Mechanical Integration of HRPPDs into pfRICH

Alex Eslinger (JLab)

12-16-2025

Challenges

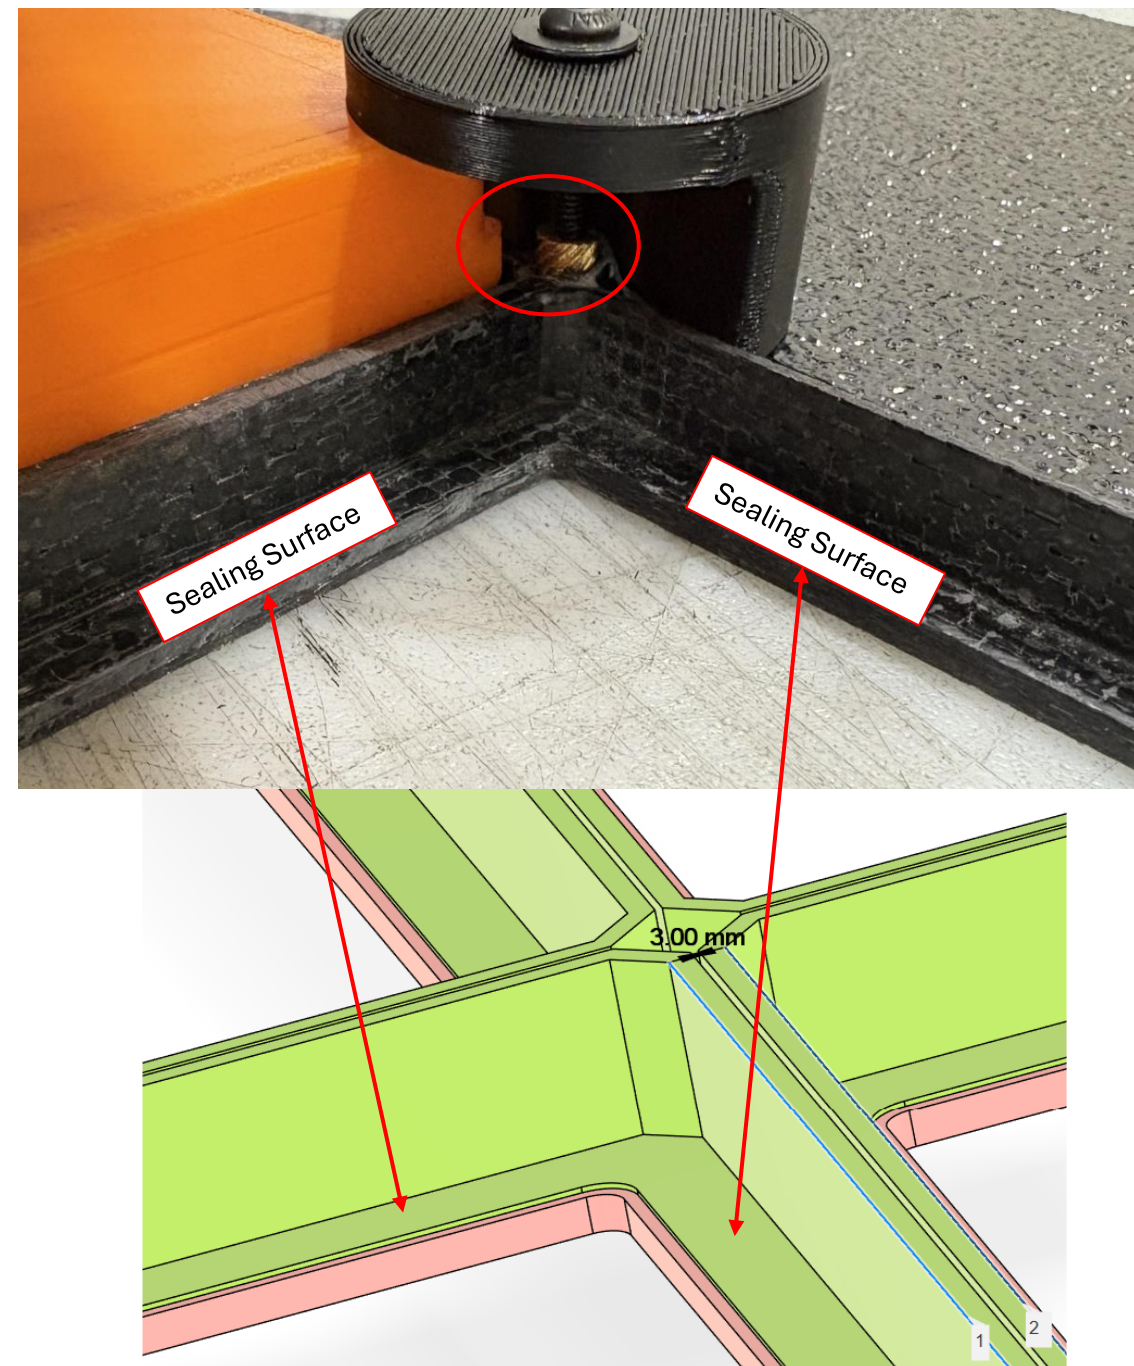
- HRPPD Spacing for the final design is ~3mm between each sensor, which drives detector acceptance, number of sensors, and mechanical interface.
 - More than 3mm, we'd lose the ability to use 68 sensors, less than 3mm means we wouldn't have the mechanical space to tile them.
- The horizontal surface – in the current design – is the location of a face seal. Face seals need consistent pressure against them to work, but we only have the locations at the HRPPD chamfered corners for hold-down screws
- This chamfer also drives the size of the inserts we can utilize

A Better Mounting Scheme

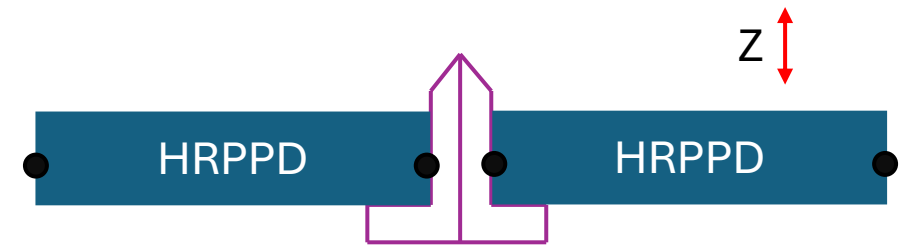
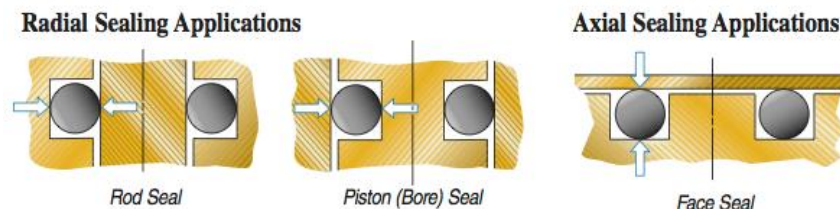
- In an ideal mounting scheme, we would have a radial O-ring around the perimeter of the HRPPD.
 - For reference, the groove would be ~2.5mm in Z and ~1.3mm deep to accommodate a 1/16" O-ring
- The interface to the sensor plane would be wedge-shaped and provide tension on the O-ring as it is pressed in.
- The hold down bolts would not be doing the sealing, they would just be to keep the sensor from coming out.
- This would require a rounded (filleted) edge on the HRPPD to have an O-ring (a chamfer would damage or cause the O-ring to leak)

Reference Sizing for Groove

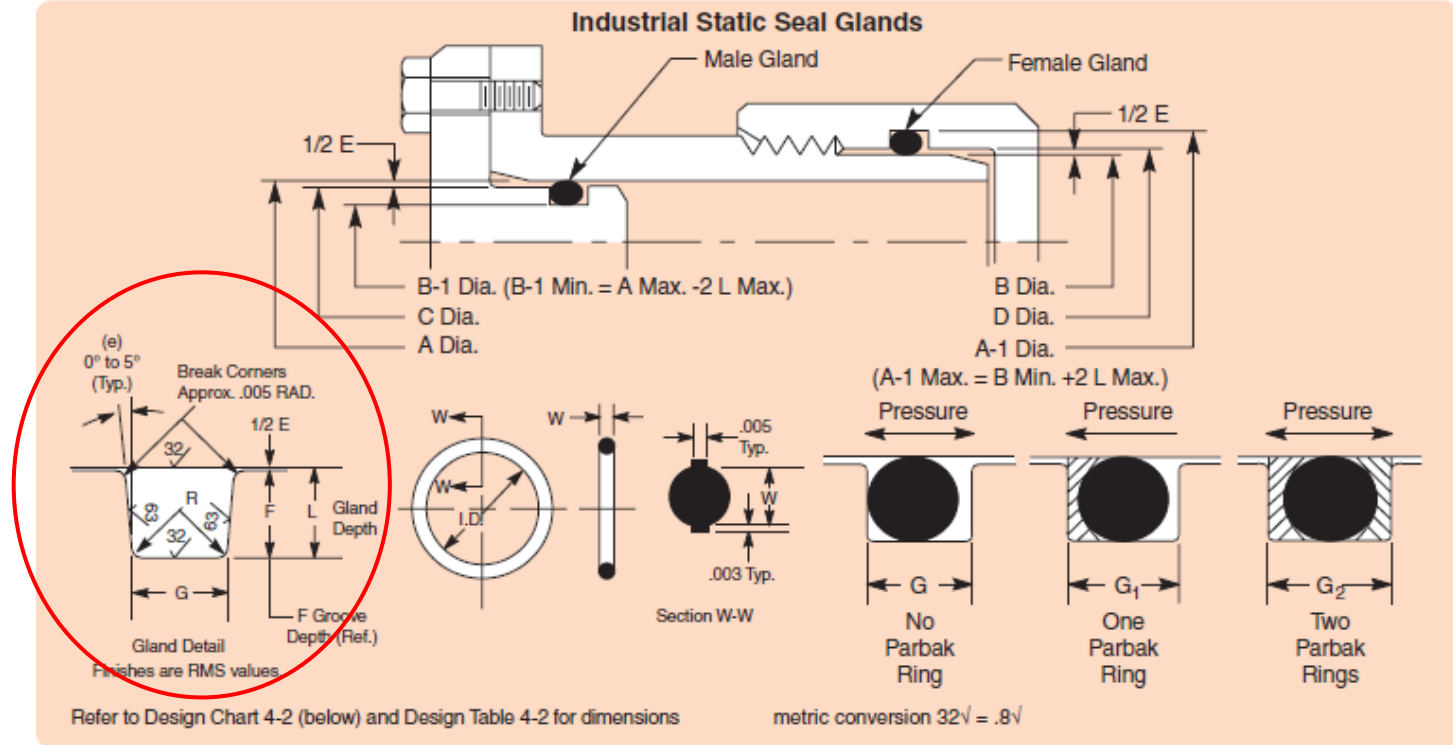
- A 1/16" O-ring needs a gland depth (L) of .050 - .052" (1.27-1.32mm) and width (G) of 0.093-0.098" (2.36 – 2.49mm)
- A 3/32" O-ring needs a gland depth (L) of .081-.083" (2.05-2.11mm) and a width (G) of 0.140-0.145" (3.56-3.683mm)
- Can we hit any of these dimensions/roughness values in the ceramic?

Prototyping efforts (Test Fit)

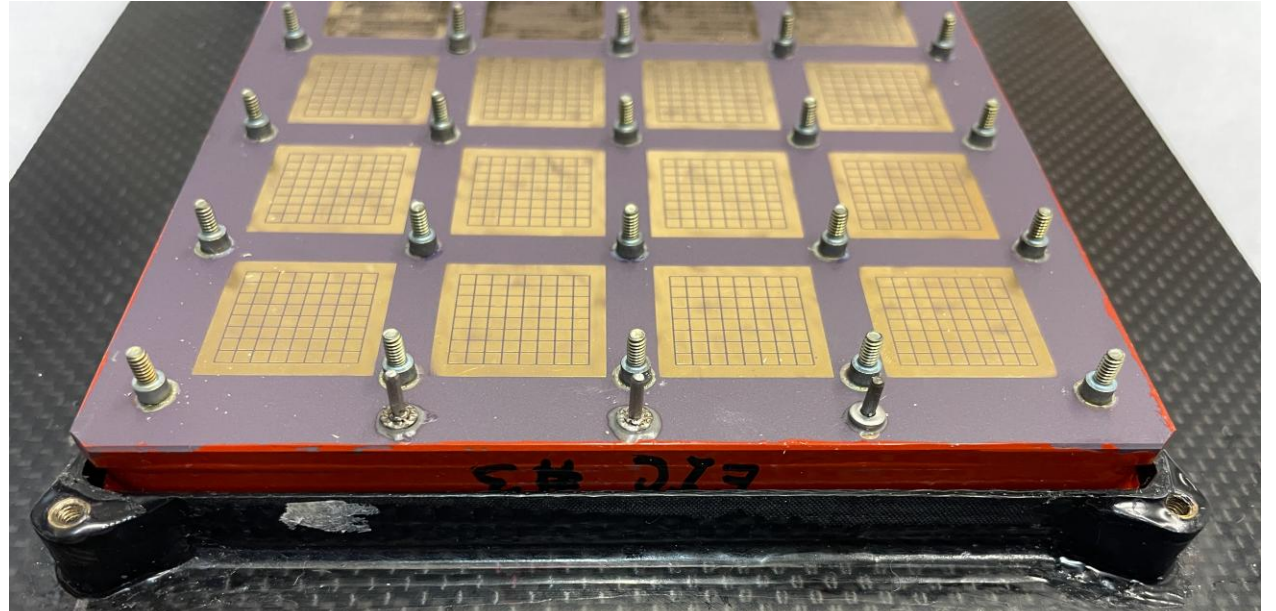
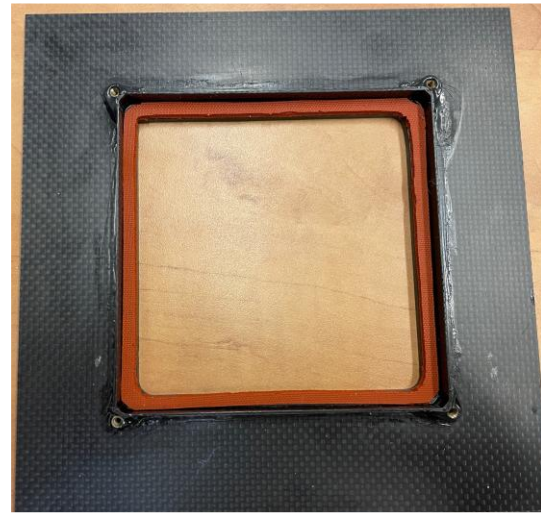
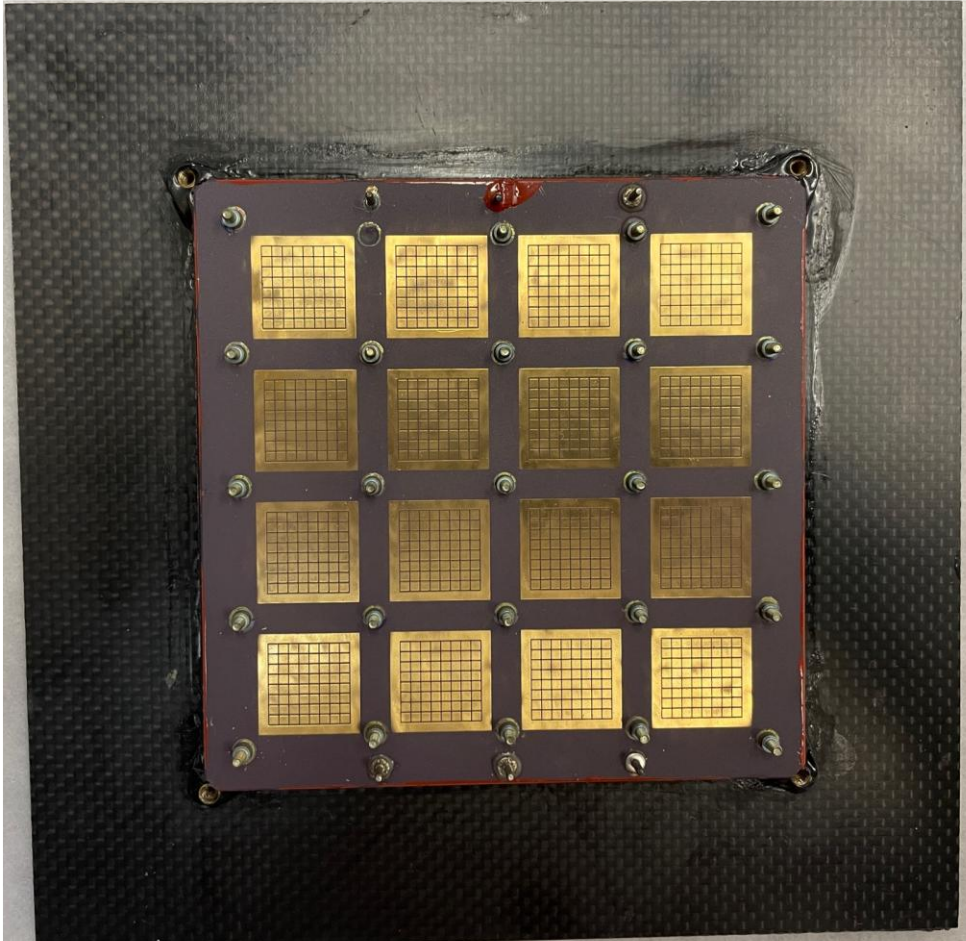
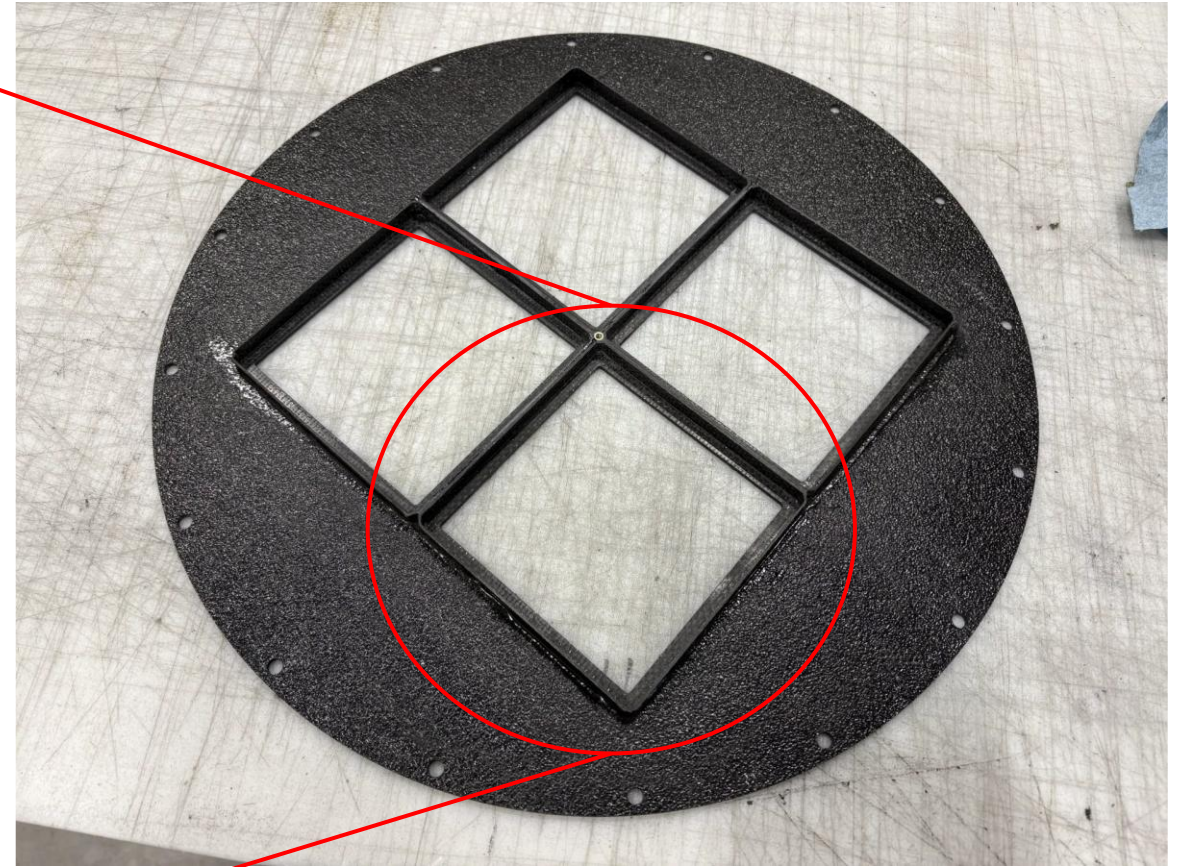
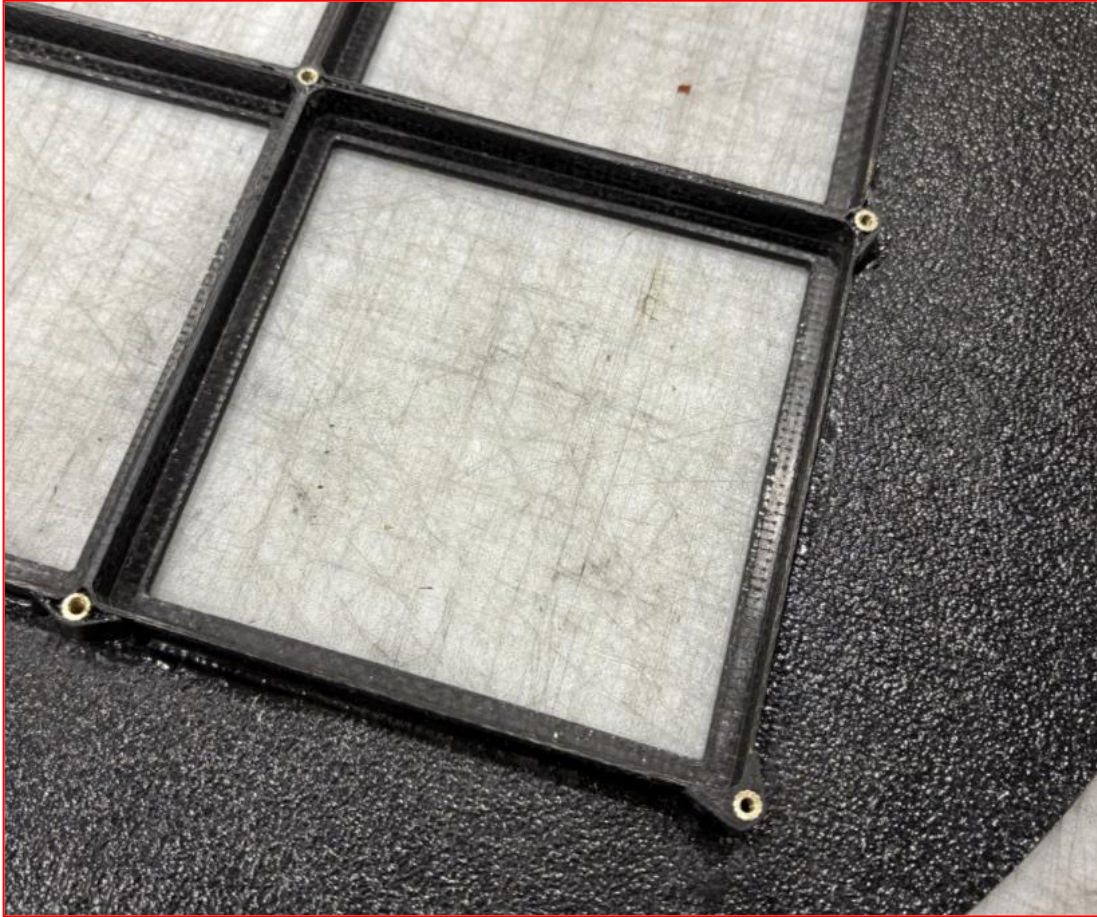
- Tried to place two different HRPPDs into this picture frame
- One worked fine, another one a bit tight -> need to improve HRPPD assembly alignment*

Chamfers

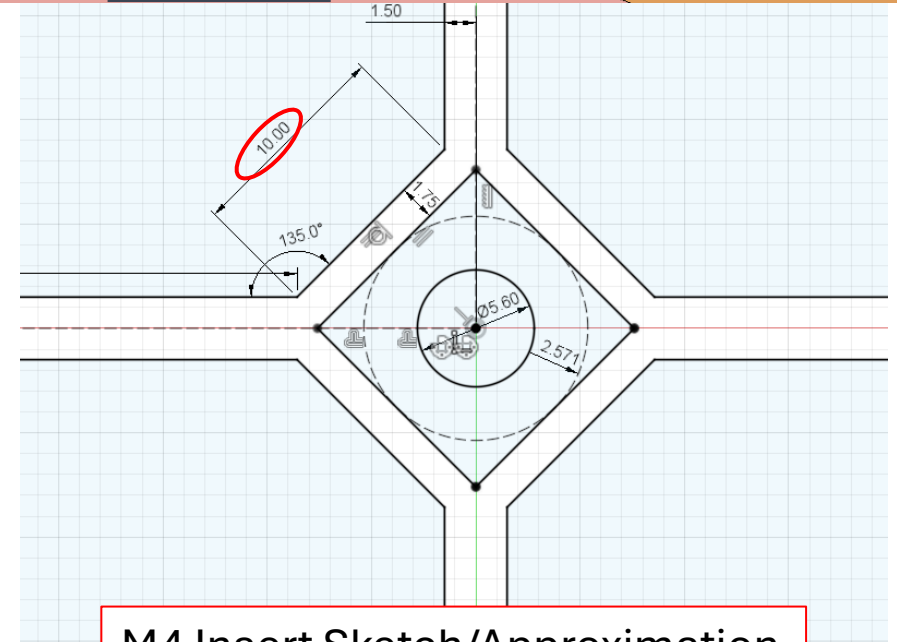
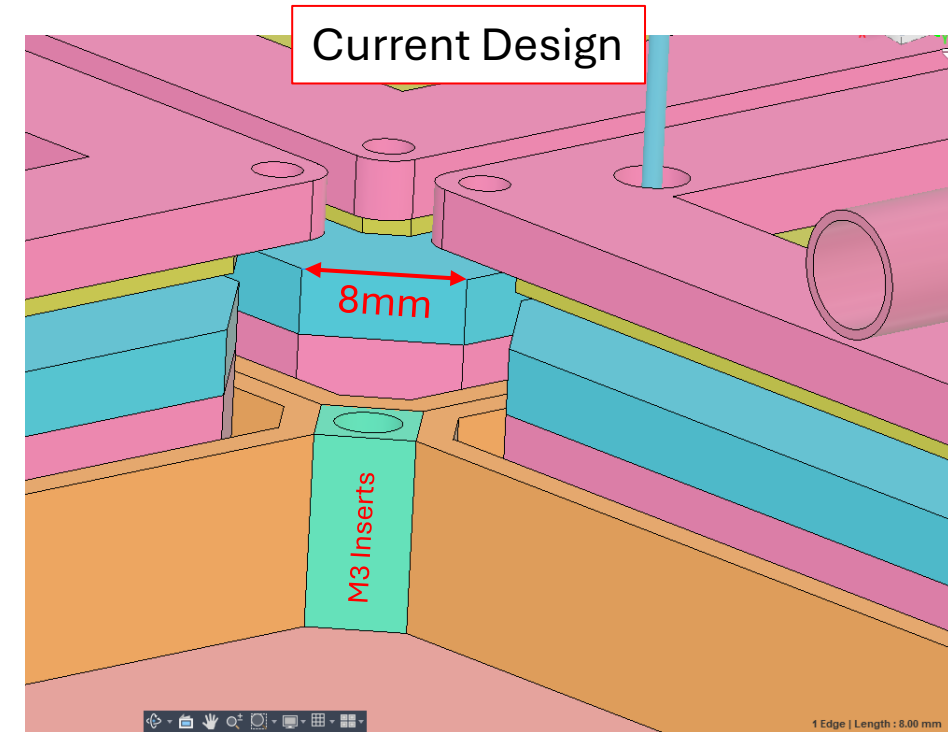
- Current chamfer (as shown in CAD) gives us an 8mm length.
- This drives the largest size of hardware we can use for the hold-down
- From the mechanical standpoint, a larger chamfer is better to allow larger inserts/hardware
- An M4 insert would need roughly a 10mm (45deg) chamfer

Fillets

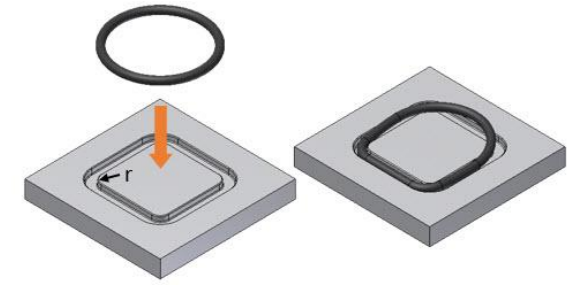
- Although I understand Kyocera cannot add fillets/rounds in the corners, I wanted to include information for reference
- For a standard O-ring, we would want the inside radius to be ideally 3 – 6 times the O-ring c-s diameter
 - E.g. 1/16” (1.78mm) O-ring needs an inside radius of 3/16” (5.34mm) at an absolute minimum
- Custom O-Seals can be molded to fit the exact grooves and a smaller radii can be used; however, we still need to consider the space for the inserts

Fillet Sketch

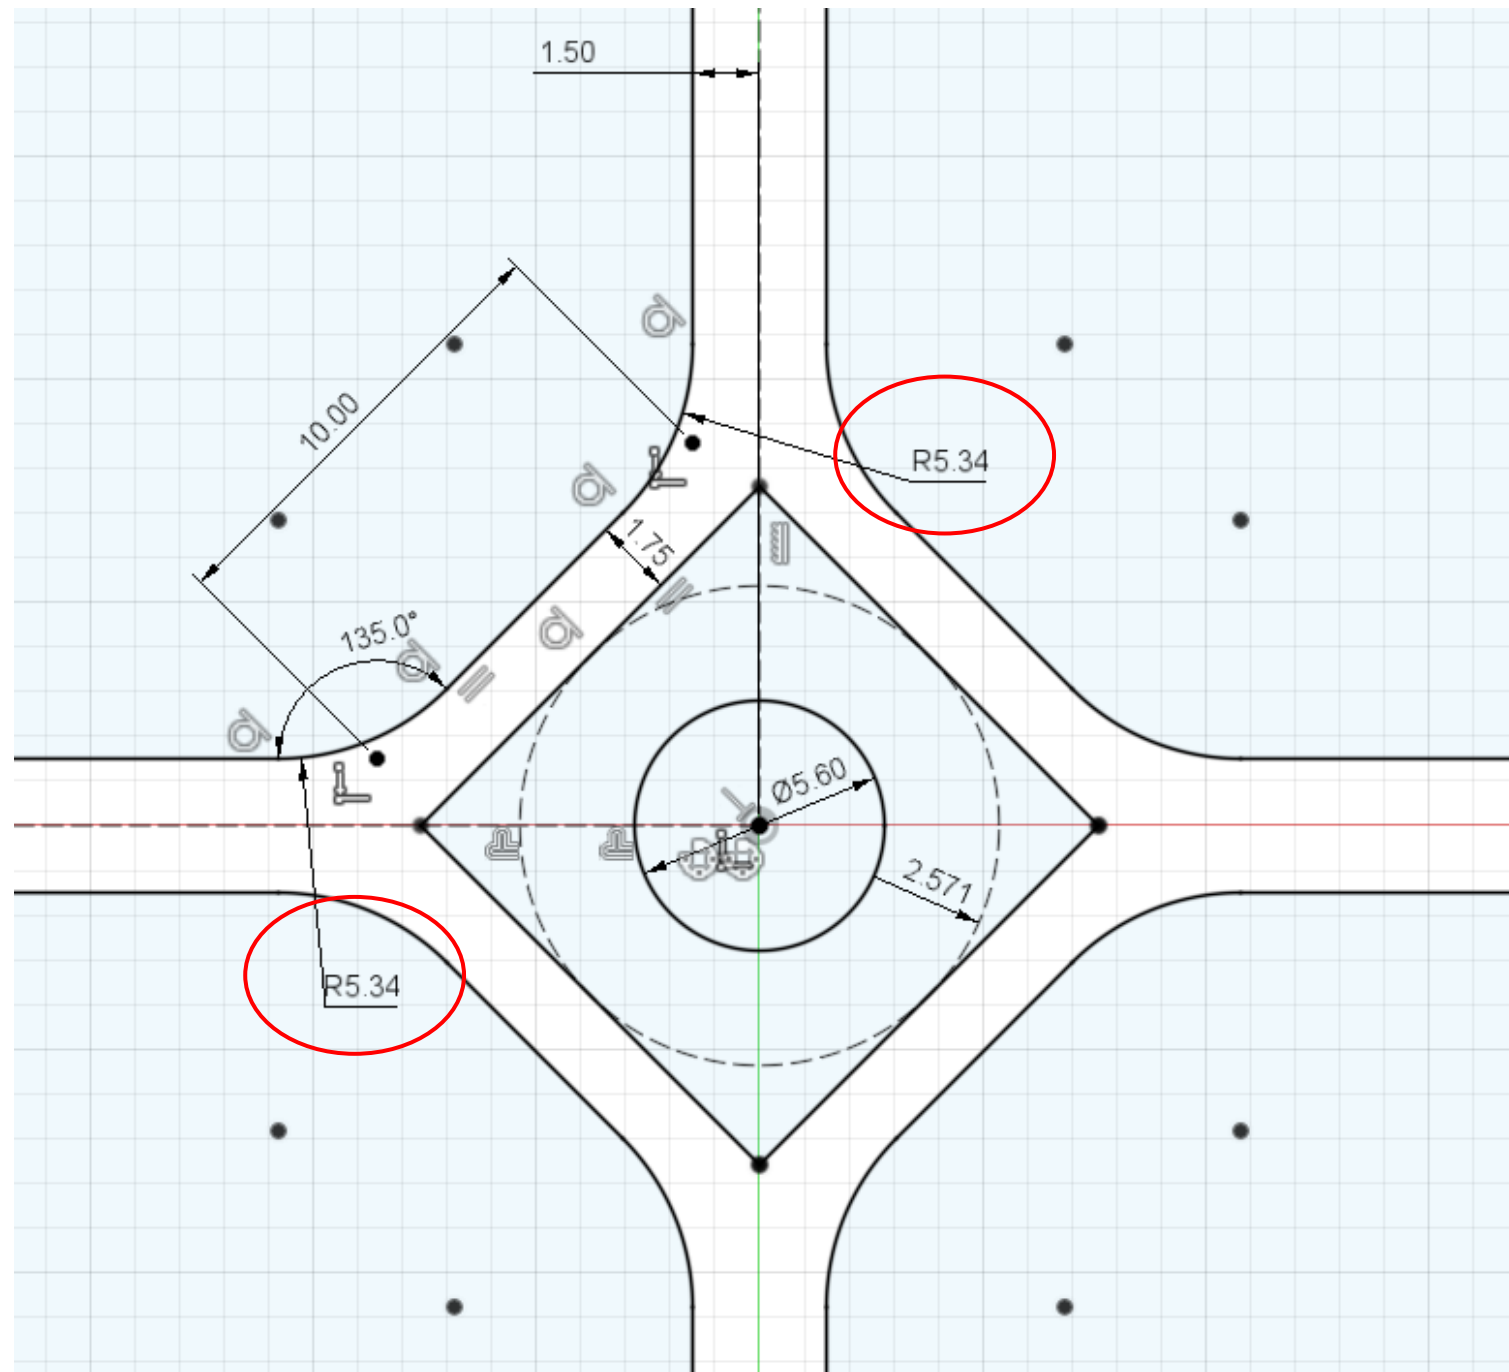
- Here's a rough sketch for the addition of fillets along the corners which makes many assumptions:
 - 1/16" O-Ring
 - 3x O-ring radius minimum
 - Upsized M4 inserts
 - 10mm chamfer
- None of these assumptions are final, this is just a visual representation of the previous slide
- This is not a proposed design option
